DART AEROSPACE LTD	Work Order:	129305
Description: Crosstube Assembly (206L High Fwd)	Part Number:	D206-667-143
Inspection Dwg: D206-667-143 Rev: C		Page 1 of 2

DRAWING NO. D206-667-143	TITLE CROSSTUBE ASS'Y (206L HIGH FWD)	REV. C	DART AEROSPACE LTD ENGINEERING ORDER		D.E.O. NO. D206-667-143-C-1	SHEET NO. SHEET 1 OF 1	SCALE NTS
DRAWN <i>q</i>	CHECKED <i>ASS</i>	MFG. APPR. <i>MB</i>	APPROVED <i>MD</i>		DE APPR. <i>MB</i>		
DATE 11.07.15	DATE 11.07.20	DATE 11.07.21	DATE 11/07/21		DATE 11.07.21

DRAWING NO. D206-667-143	TITLE CROSSTUBE ASS'Y (206L HIGH FWD)	REV. C	DART AEROSPACE LTD ENGINEERING ORDER		D.E.O. NO. D206-667-143-C-2	SHEET NO. SHEET 1 OF 1	SCALE NTS
DRAWN AJS	CHECKED	MFG. APPR.	APPROVED		DE APPR.		
DATE 12.08.02	DATE 12.08.02	DATE 12.08.02	DATE 12.08.02		DATE 12.08.02

TURNING DETAIL

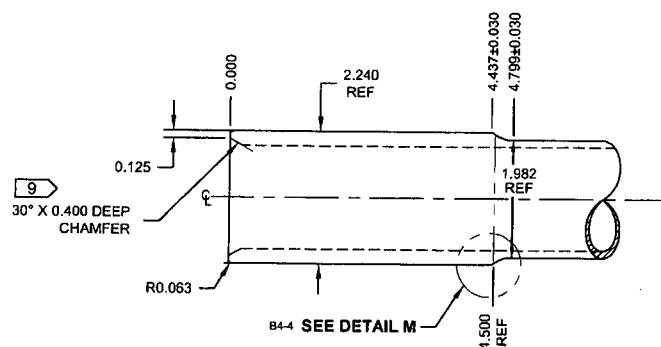
1-Fill tube with sand & install plugs DT8534 on both ends as per Folio FA087

2-Turn first side as per Folio FA087

3-Blend transition lines only, **do not sand whole tube**:

*Use mill bastard file, brush file repeatedly with file card.

*Do not use sandpaper coarser than 320 grit.

DETAIL P
BONDING STRAP INSTALLATION 2 PL

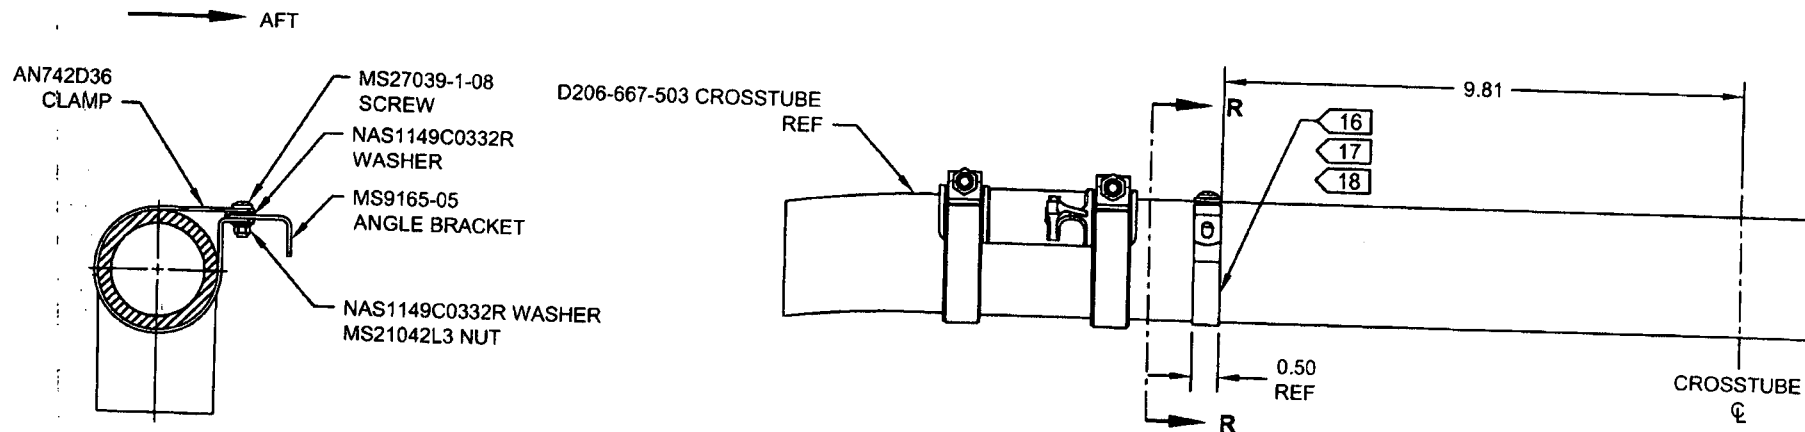
ADD ELECTRICAL GROUNDING STRAP

ITEM	QTY -143	PART NUMBER	DESCRIPTION
1	X	D206-667-143	CROSSTUBE ASSEMBLY (206L HIGH FWD)
10	2	AN742D36	CLAMP
11	2	MS9165-05	ANGLE BRACKET
12	2	MS21042L3	NUT (OR MS21042-3)
13	2	MS27039-1-08	SCREW
14	4	NAS1149C0332R	WASHER (OR AN960C10L)

- 16) MASK AREA UNDER CLAMP PRIOR TO PAINTING
- 17) SEAL EDGES WHERE AN742D36 CLAMP MEETS WITH THE CROSSTUBE USING SIKAFLEX-241/-291 OR MIL-S-8802 CLASS B2 OR PROSEAL 890 SEALANT
- 18) PERFORM RESISTANCE CHECK TO ENSURE MAX RESISTANCE IS 10 MILLIOHMS
